Harry Hurst Middle School  
Wing Addition  
Addendum No. 5  
August 4, 2010

## ADDENDUM NO. 5

**PROJECT:** HARRY HURST MIDDLE SCHOOL  
NEW WING ADDITION  
170 ROADRUNNER LANE  
DESTREHAN, LA 70047

project no.	date	drawing number
10078	8.4.2010	SK-1
file name	sheet/A.3.0.dwg	
issued for	Addendum #5	this drawing modifies A-16/A.3.8

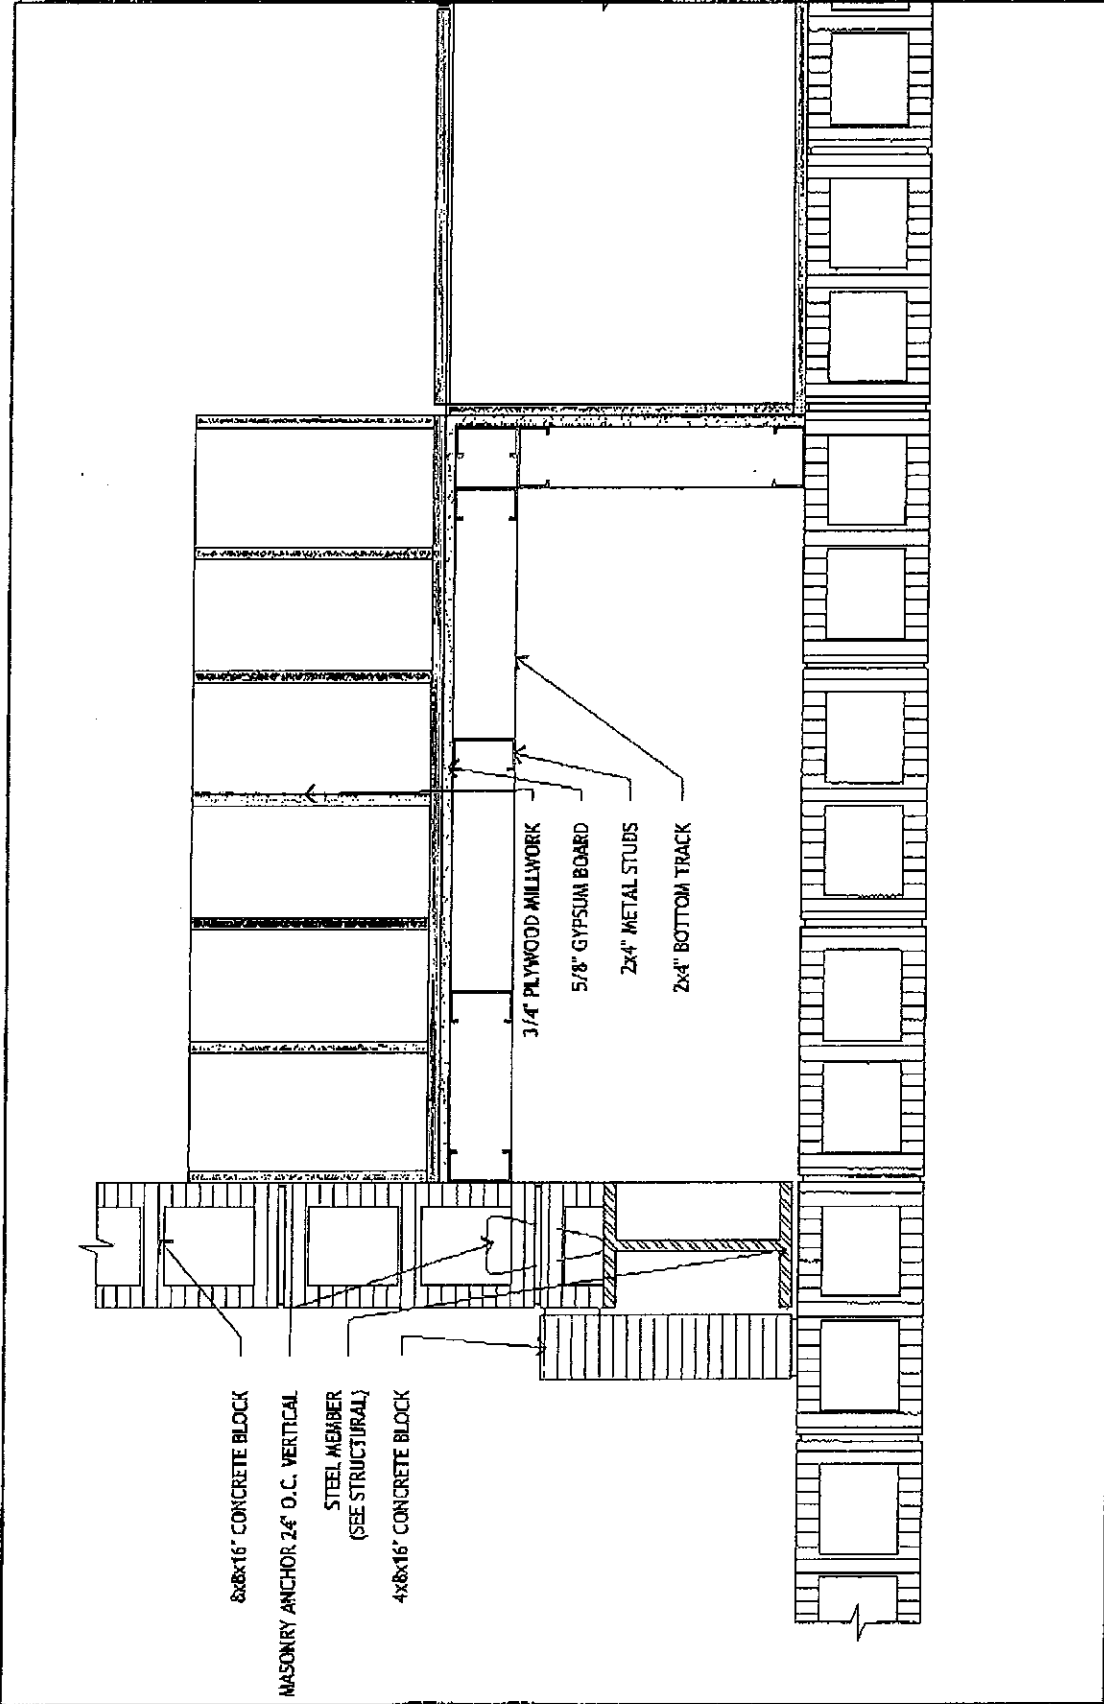
1. See attached Sketches SK-1, SK-2, SK-3 and SK-4.
2. Sheet A.7.4, Detail E-13. Please remove rebar from concrete stair treads.
3. Sheet C.1.3. Remove and replace with the attached sheet.
4. Sheet C.2.1. Add to the contract documents.
5. Contractor to provide and install eight (8) student lab tables and two (2) teacher lab tables as detailed in the attached Sketch SK-3.
6. Sheet A.2.2, Detail A-7. The downspout boot shall be 8"x8" cast iron boot by McKinley Iron Works. Boot shall be powder coated to match downspout color.
